# PENRITH CITY COUNCIL

## MAJOR ASSESSMENT REPORT

<b>Application number:</b>	DA20/0365.02
<b>Proposed development:</b>	Section 4.55(1A) Modification to Approved Residential Flat Building to Reconfigure Bedroom Allocation, Internal Layout, and Balcony Arrangement of Units 18 and 19
<b>Property address:</b>	26 Hope Street, PENRITH NSW 2750 28 Hope Street, PENRITH NSW 2750 30 Hope Street, PENRITH NSW 2750
<b>Property description:</b>	Lot 35 DP 31239 Lot 36 DP 31239 Lot 34 DP 31239
<b>Date received:</b>	17 September 2021
<b>Assessing officer</b>	Sandra Fagan
<b>Zoning:</b>	SEPP WSA - Affected by Obstacle Limitation SEPP WSA - Affected by Wildlife Buffer Zone Zone R4 High Density Residential - LEP 2010
<b>Class of building:</b>	Class 2 , Class 7a
<b>Recommendations:</b>	Approve

Unit 18 - proposed change to southern (rear) elevation - shown in image above - compared to the approved elevation shown in the image below. The difference can be seen by the amount of solid wall between W23 and W1 and the increase to the number of privacy battens in that same area.

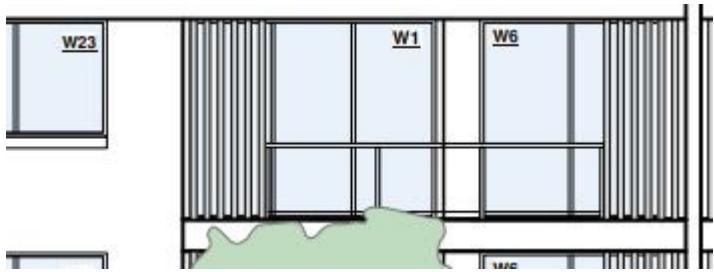
The proposed modification also includes repositioning a western (side) facing glazed door of Unit 19, 470mm to the north and also lengthening the corresponding balcony by 470mm. The southern (rear) facade of Unit 18 is proposed to be altered by increasing the length of the balcony by 640mm and also lengthening the corresponding privacy screen. In context, these external changes will be visually negligible, as demonstrated in the excerpts below.

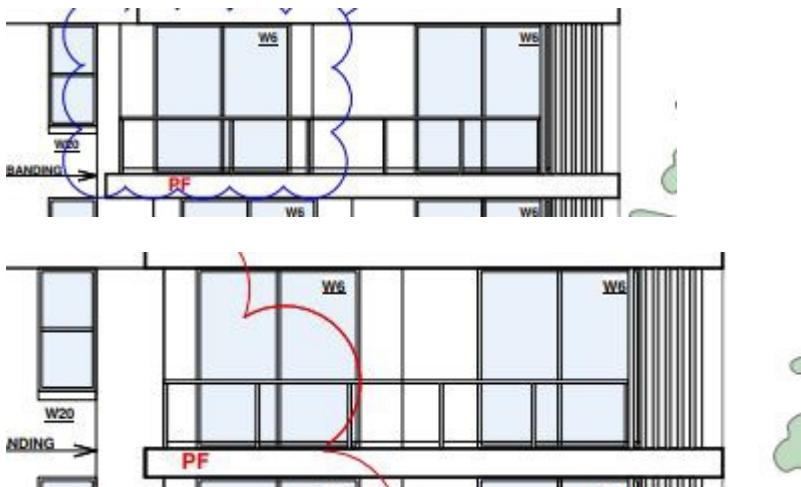
The two images below show the western (side) facade of Unit 19, with the proposed facade detail shown in the first image and the approved facade detail shown in the second image. W6 which is a glazed door is proposed to be slightly repositioned by 470mm and the balcony also lengthened by 470mm. The difference can be seen when comparing the amount of solid wall between W20 and W6.

However, the loss of the southern facing bedroom from Unit 19 results in that apartment no longer being cross ventilated. This is acceptable in this instance as it is only 1 less cross ventilated apartment, resulting in 24 of the total 38 apartments being cross ventilated (instead of the approved 25). Expressed as a percentage, the proposed modification would result in 63.16% of apartments being cross ventilated instead of the approved 65.79%. Although numerically, this is a non-compliance, it is considered that Unit 19 still retains very good amenity, given that the unit is over-sized for a 2 bedroom unit, has a generous balcony that receives good afternoon sun and that air from the south can also penetrate the unit from the balcony return on the southern elevation. Although it would be possible to achieve compliance by installing a window into the southern elevation of a bedroom of Unit 19, this is not considered necessary as it would disrupt the internal planning for the room, given that a glazed door is proposed on the western elevation to directly access the balcony.
